Product Change Notice (PCN)

PCN Number: PCN-0455122R-01

Product(s) Affected: *PJ-068B-SMT-TR*

PREVIOUS CUI DEVICES DETAIL / IMAGE NEW CUI DEVICES DETAIL / IMAGE

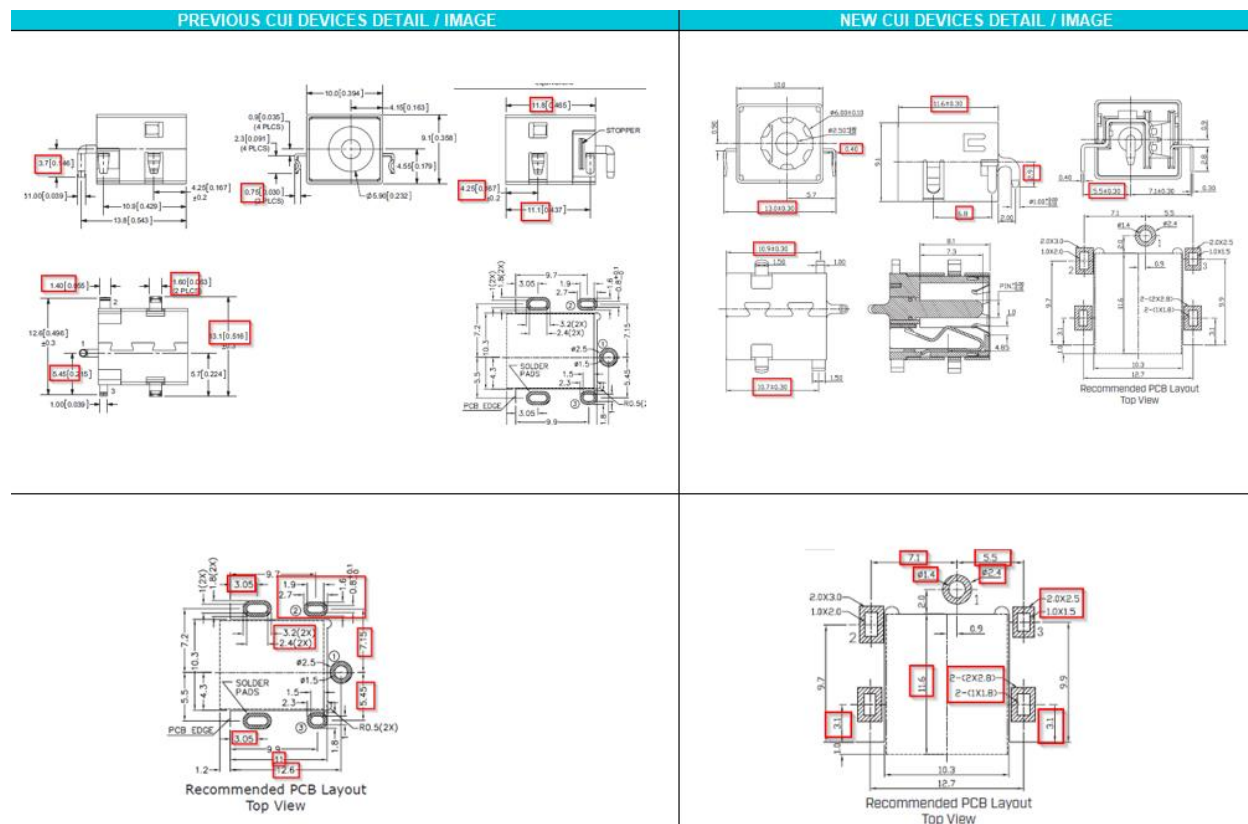
Description of Change: *Minor Housing and footprint differences. Material Change on the housing and terminals. See image Below*

MATERIAL	PLATING
center pin	brass	silver
terminal 1	brass	silver
terminal 2	copper alloy	silver
terminal 3	brass	silver
stopper	cold rolled steel	nickel
shield-A	brass	nickel
shield-B	stainless steel	
plastic	PA6T or equivalent

DESCRIPTION	MATERIAL	PLATING/COLOR
center pin	zinc alloy	nickel
terminal 1	zinc alloy	nickel
terminal 2	bronze t=0.30	silver
terminal 3	brass t=0.40	silver
shield-A	iron t=0.30	nickel
shield-B	SUS301 t=0.10	
housing	PA6T (UL94V-D)	black
